Applicable Urban Design Priorities Project Should Achieve

Trinity Groves Phase II Residential

Neighborhood:
West Dallas

Program:
Residential/ Retail

Akron Street Open Space Conceptual Plan

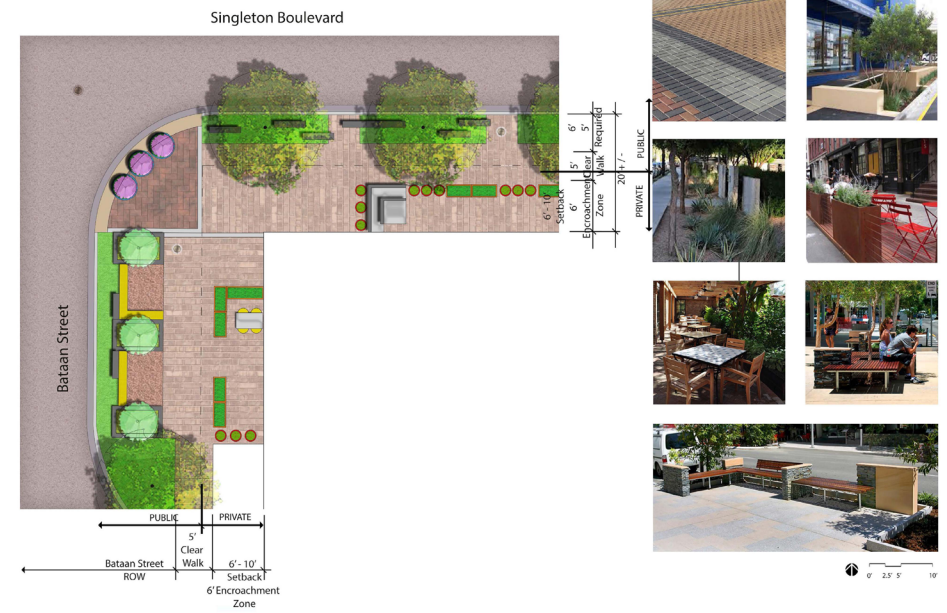
- [2] Explore a pedestrian scale pass-through between Acron and Singlton as both a mid-block pedestrian connection through the site and as an extension of the park -
Screen garage facade at the pedestrian level along pass-through with architectural or vegetative screening elements, and explore opportunities to locate individual ground floor unit access along pedestrian pass-through as an opportunity to create a more permeable and connected block.

Entry Drive Conceptual Plan

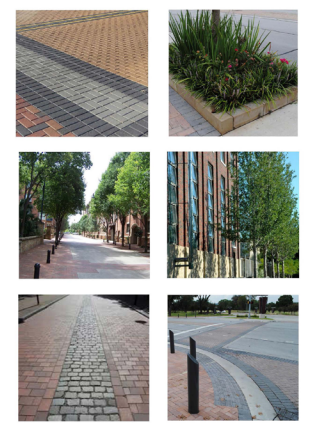
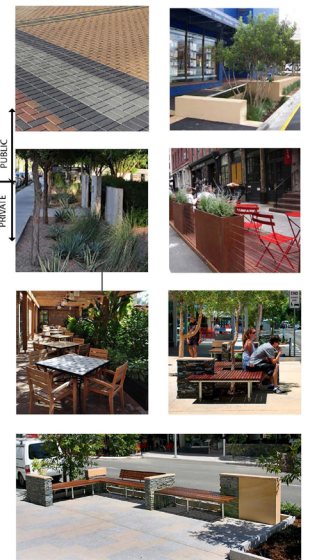
- [1] Utilize non standard access drive detail that maintains sidewalk level through access drives to maintain level sidewalks for pedestrians -
Utilize drive entry details that maintain a consistent grade the pedestrian throughway for both garage entrances and also through the proposed fire lane.
